Town of Kittery Planning Board Meeting August 9, 2018

459 U.S. Route One – Site and Subdivision Preliminary Plan Review

Accept or deny application. Owner, Landmark Properties LTD, and applicant, Michael Brigham, request consideration of a mixed-use development consisting of a 112-room hotel, and three residential buildings with 32 elderly housing units and 16 residential units located at 459 U.S. Route 1 (Tax Map 60 Lot 24) in the Mixed Use (MU) Zone. Agent is Ken Wood, Attar Engineering.

1.1

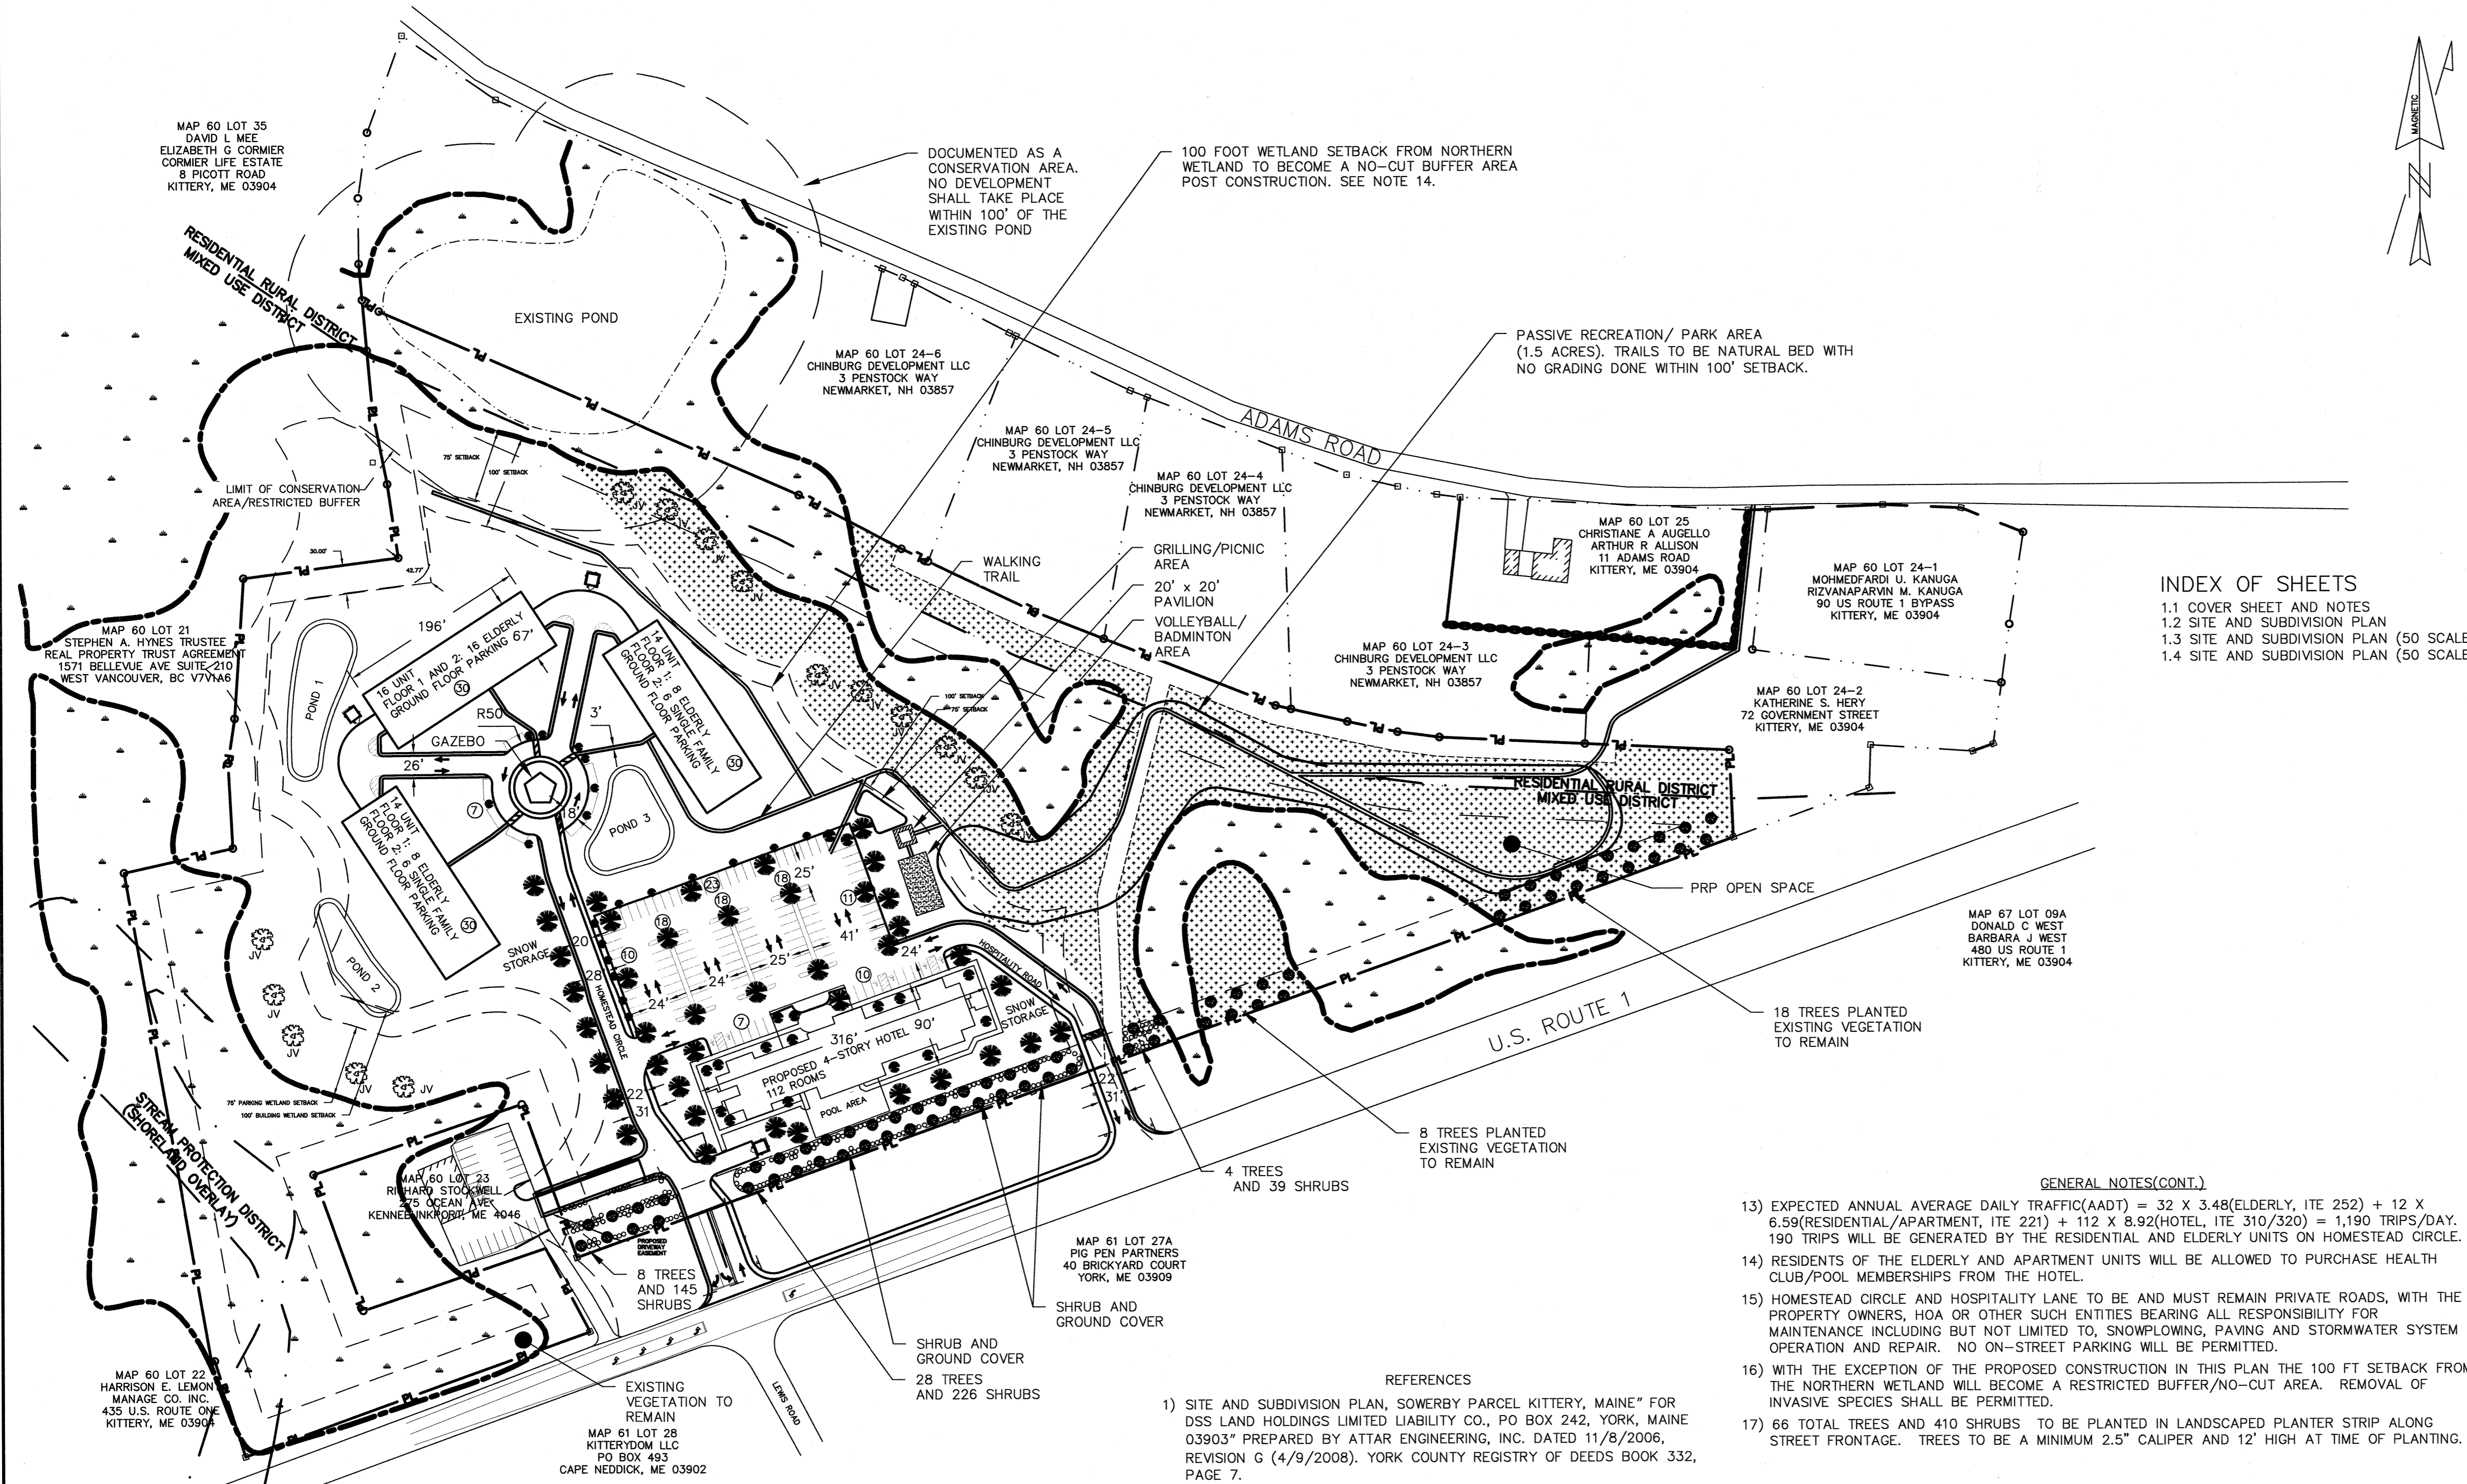
3. Plan note 14 states that the owners of the two types of residential units will be able to purchase health club and/or pool memberships from the hotel. This could be considered towards addressing 16.3.2.13.D.10.F's requirements for elderly housing to be integrated and to provide pedestrian access to services and facilities within the area for the residents of the elderly housing.

4. Note 6 shows the net residential calculations. It appears that the travel ways, easements and parking numbers have been re-calculated due to the change in uses and are slightly more (2.85 acres rather than 2.51 acres) than the previous approved preliminary plan. Elderly housing is allowed at 10,000 sf per unit because of the parking provided within the building and being on public sewer. The other dwelling units are similarly allowed at 7,500 sf per unit because of the ground floor parking and access to sewer.

5. Note 7 demonstrates that the smallest use in terms of floor area, single-family dwelling units, exceeds the 10% minimum requirement per 16.3.2.13.D.4.
6. Section 16.3.2.13.D.10.E includes several additional requirements for a motel or hotel. The first encourages a multi-story building, which it appears the proposed building may be, but the plans do not say. The second states that *wherever practicable building orientation should not be parallel with U.S. Route 1 but must take maximum advantage of the depth of the mixed-use zone*. The proposed hotel is parallel to Route 1 with additional development behind it. The third requirement is that more than three motels and/or hotels are not allowed in the mixed-use zone. There are currently no motels or hotels in the mixed-use zone.

12. Daily traffic counts are shown in Note 13. The residential uses will generate only about 10% of the total traffic with the hotel generating the rest of the 1,190 trips per day. Both the number of trips per day and the number of parking spaces will trigger the traffic impact analysis requirement as stated in Section 16.10.5.2.C.10. The applicant is aware that a Traffic Impact Analysis is required.

15. The roads will be private (see Note 15 on the plan) and the plans show the road at about 22 feet wide plus sidewalks and shoulders near the hotel, then narrowing to 20 feet towards the residences. The width of the sidewalks varies, with the portion nearest the hotel at 6 feet and then narrowing to 5 feet as Homestead Lane moves towards the proposed residences.
16. Parking for the hotel is located behind the building as required by Section 16.3.2.13.D.5. Parking for the residential units is shown as 30 spaces on the ground floor of each building (90 spaces total) which is more than the 24 parking spaces required. The hotel parking includes 1 space per room (112) plus 3 additional spaces for a conference room (1 space per 100 sf of meeting room area).

OVERALL SITE PLAN
 THE HOMESTEAD
 459 US ROUTE 1 KITTELY, MAINE

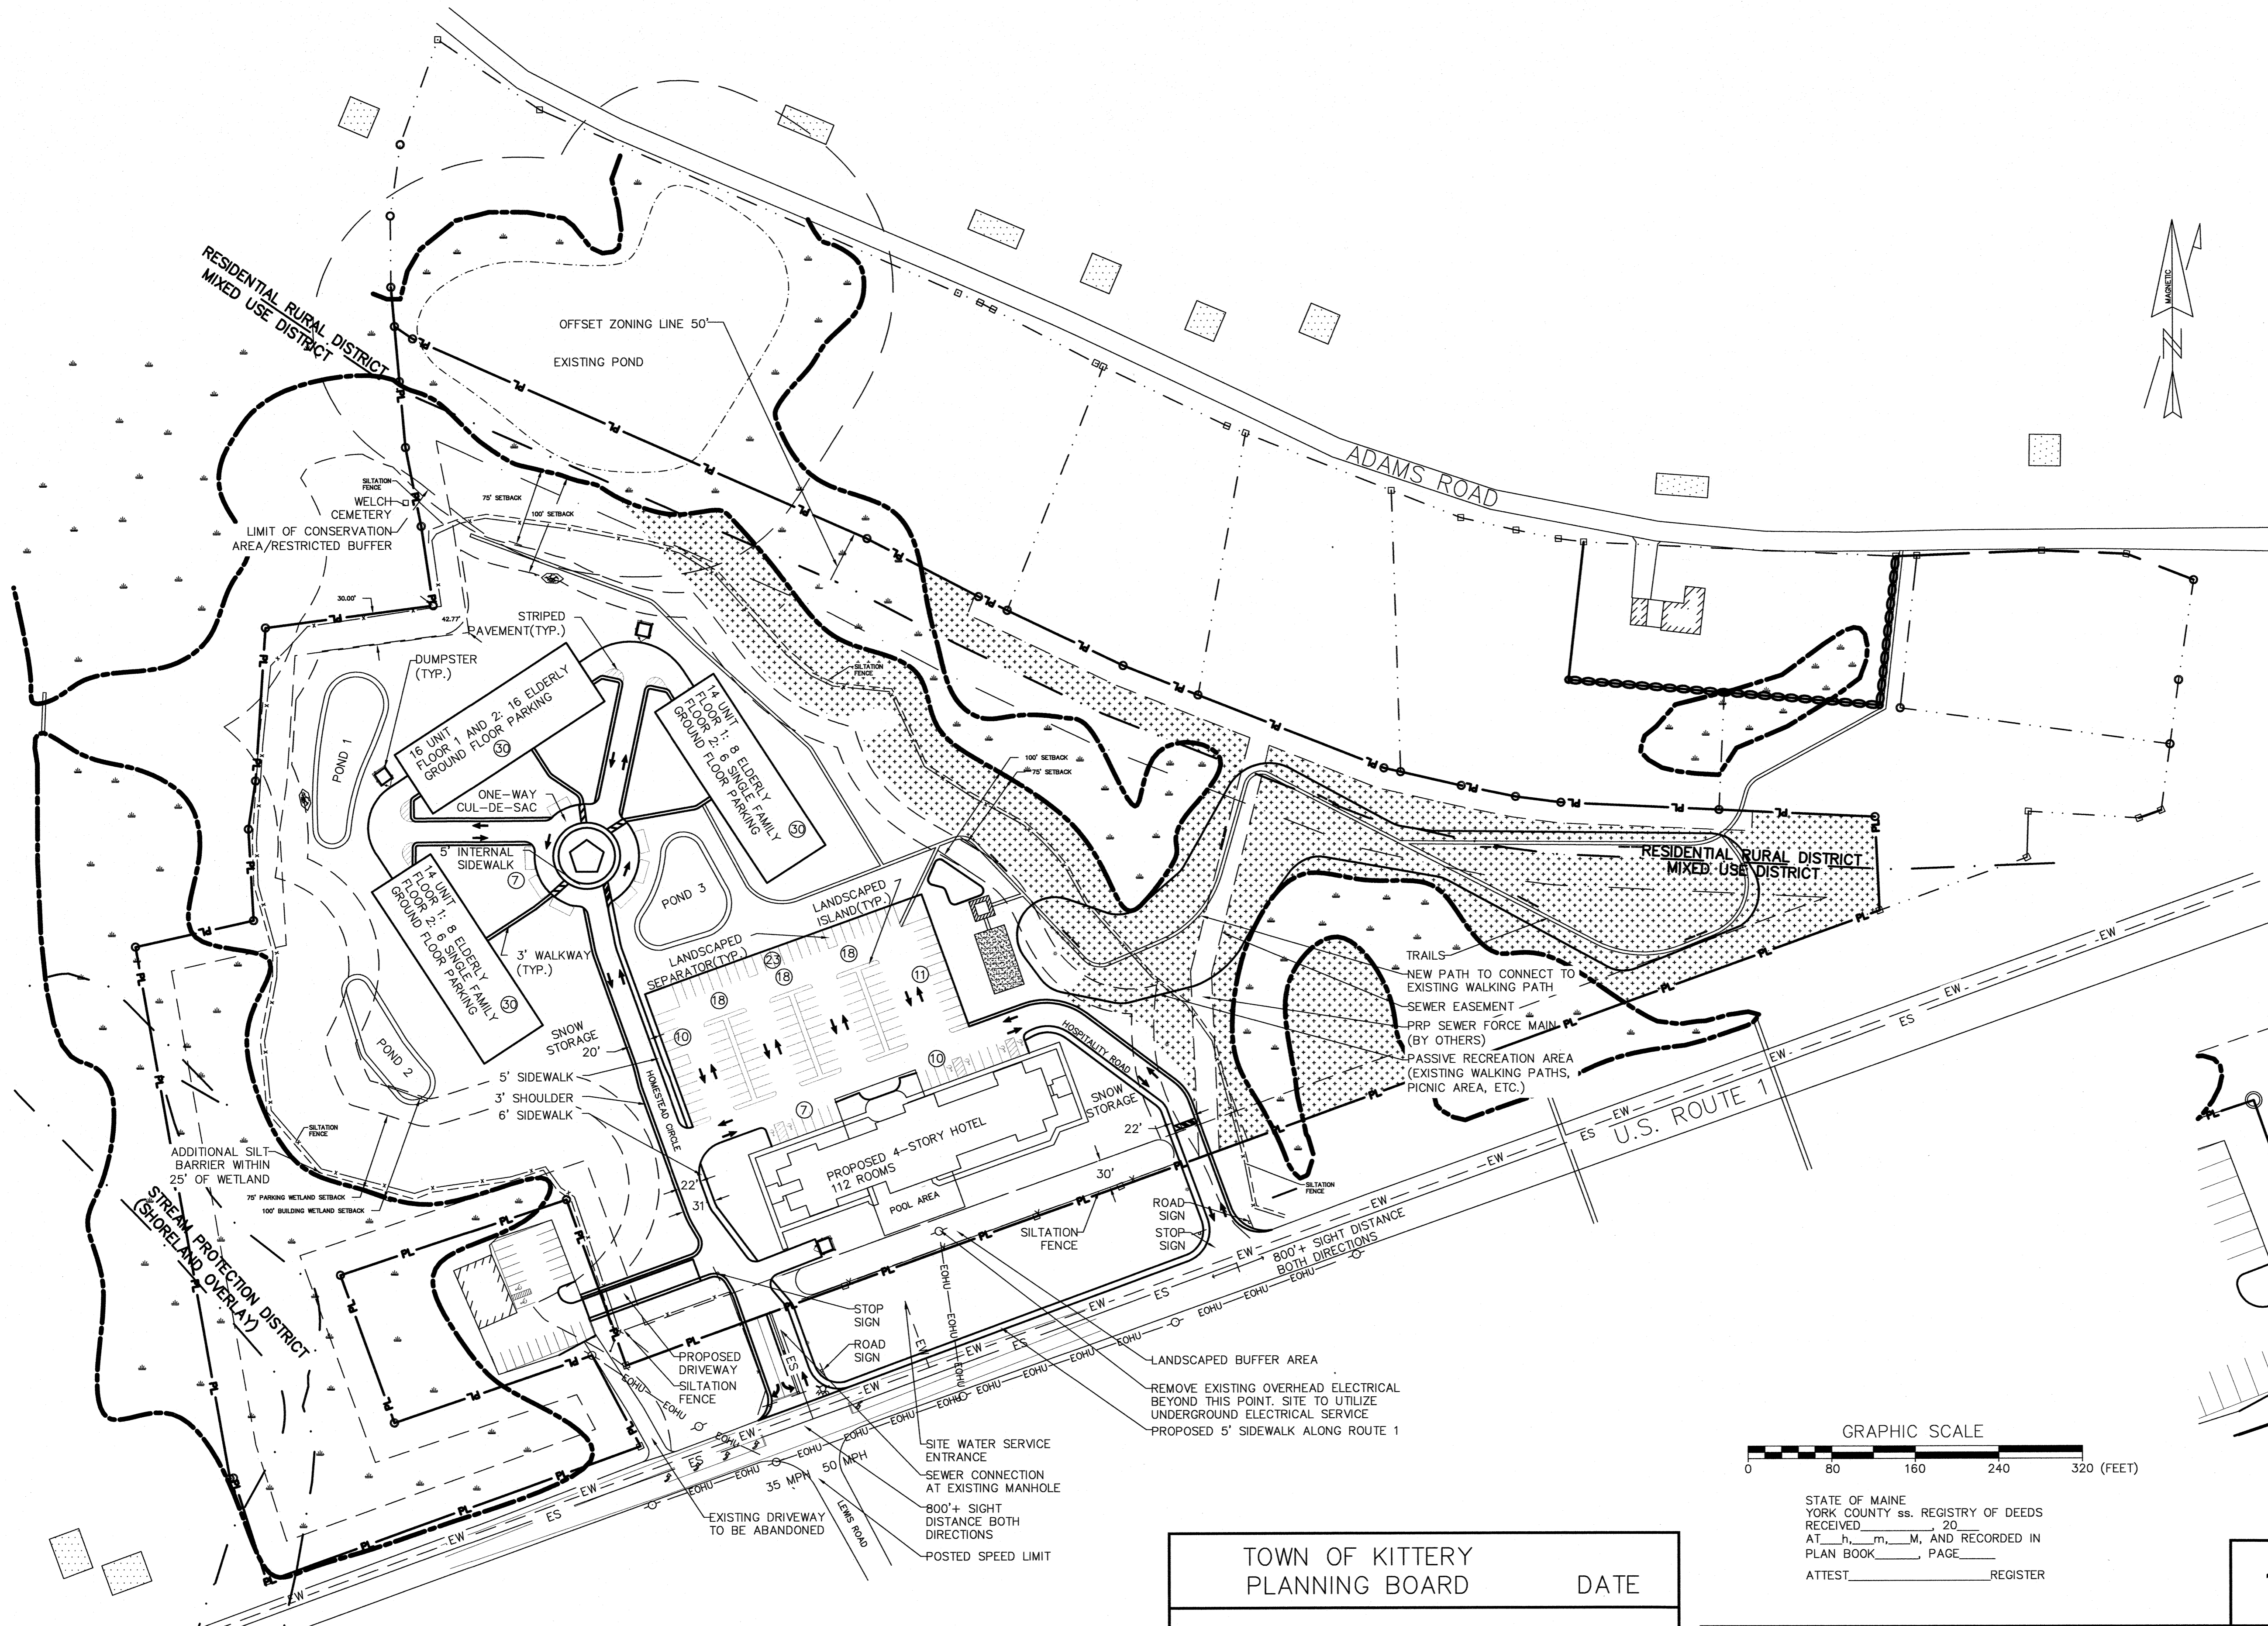
- a. The plans now show a grilling/picnic area; 20'x20' covered pavilion and volleyball/badminton area;
 - b. The plans now show a passive recreation/park (1.5 acres) which will include trails with a natural bed and will involve no grading within the 100' setback.

10. Wetland setbacks are shown at 75 and 100-feet. No drainage structures are proposed for the northern wetlands which are wetlands of special significance. Two drainage structures are proposed for the southern wetlands – one is beyond the 100 foot setback and one is between the 75 and 100 foot setbacks. A third, rather large stormwater pond is within the developed area of the residences.

11. A note on the plan specifies the 100-foot buffer to the north will be a designated no-cut buffer. Staff also recommends that it be a no-disturb buffer. Staff will provide applicant applicable wording for the plans and for the HOA documents.

13. Section 16.8.4.2.C states that any development that exceeds a daily average of 200 trips per day must have two entrances/exits to a public road. The same section, 16.8.4.2.F states that entrances/exits onto an existing arterial or secondary arterial must be at least 1,000 feet apart. The plan shows two entrances which while required, do not meet the second requirement that they be spaced 1,000 feet apart. A large wetland to the north along the road factors into the location of the entrances.

17. Per Section 10.8.9.4.G *Parking Standards*, landscaping is required for the hotel parking area since it contains well over 10 spaces. One tree is required for every parking space. There are 14 trees shown in the parking area which meets the requirements (115 parking spaces / 8 spaces = 14 trees).

18. Trees line the road called Homestead Lane and are also shown along all sides of the hotel building and on one side of the other road called Hospitality Road. The Applicant appears to be demonstrating that fairly extensive landscaping will be provided. While no detailed landscaping plan has been submitted, it will be for the next Planning Board meeting on the project.

19. The landscaping requires a 30-foot landscaped buffer strip per 16.3.2.13 along the length of the developed portion of the property's frontage. The plan shows landscaping including trees and shrubs along much of the property except in the wetlands that abut Route 1. Note 10 has been revised to include a mixture of evergreen and deciduous trees to be planted every 25 feet on centerline with a mix of 10 shrubs and/perennials for every 40 feet of frontage.

Elderly housing – A large part of the discussion during the Planning Board meeting included whether or not offering memberships to the hotel's fitness and pool areas met the Elderly Housing requirements for the Special Exception Use. As shown in the attached plans development of the passive recreation area has been expanded to include areas set aside for outdoor games, benches, picnic tables and grills. The trail has been located closer to the forested area to provide further screening from structures. Also a 20' X 20' 3-season pavilion is proposed to be located between the hotel parking lot and the walking trails.

Although the entrances have not changed since the initial submission we respectfully request a waiver of 16.8.4.2.F to allow the entrances to be less than 1000 feet apart. The proposed entrances are approximately 400 feet apart and the Maine Department of Transportation has issued an entrance permit for the Sowerby Project.

As noted in the Staff Review as well as during the Planning Board Meeting a mixture of evergreen and deciduous trees will be provided as part of the overall landscaping plan in order to avoid any blight on specific trees from damaging the overall landscape. The species will be detailed as part of the Preliminary Plan Submission.
